ATTACHMENT T:

ADDENDUM 1

**CHILDREN AND FAMILY JUSTICE CENTER
CONTRACT NUMBER C00863C13**

Addendum Number 1

Figure 4-6

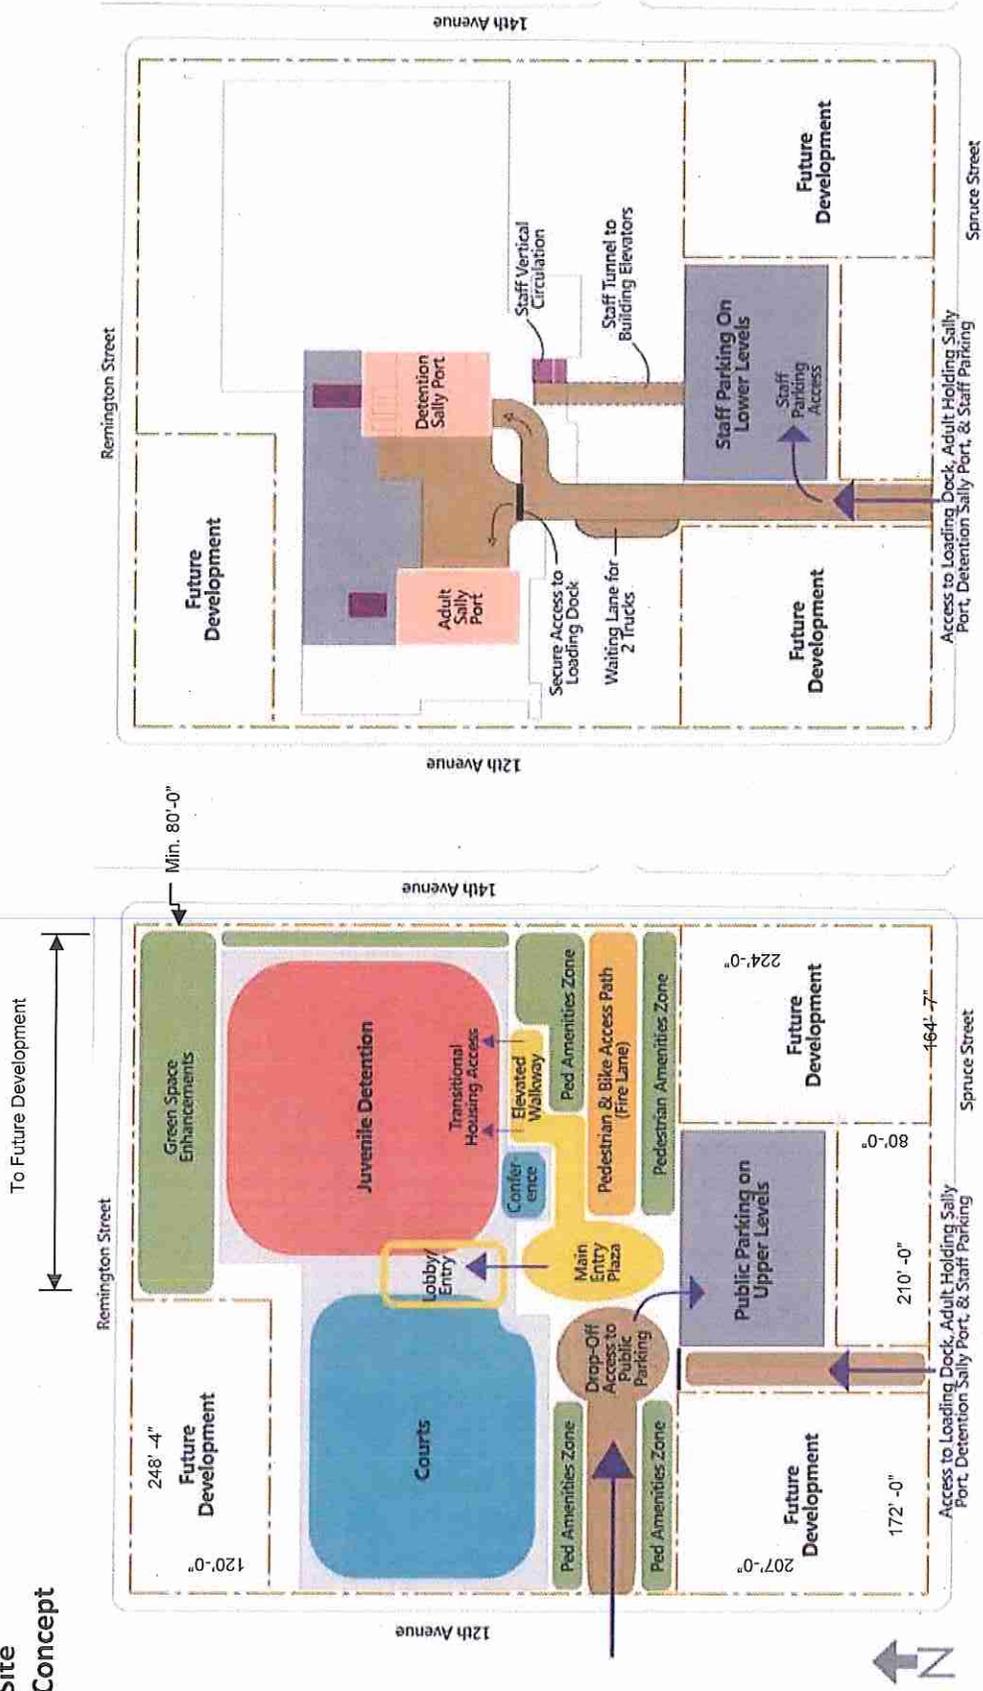
| Ref. | Page or Drawing | Location and Description of Change |
|------|-------------------|---|
| 1.22 | 4-15 | <p>DELETE Figure 4-6 and REPLACE with Revised Figure 4-6. See attached.</p> |

| Ref. | Page or Drawing | Location and Description of Change |
|------|-----------------|--|
| 1.49 | | <p>Q: What are the minimum dimensions of the open space?</p> <p>R: See attached revised Figure 4-6.</p> |

Note The minimum overall dimensions of "Future Development" parcels are indicated as shown above.
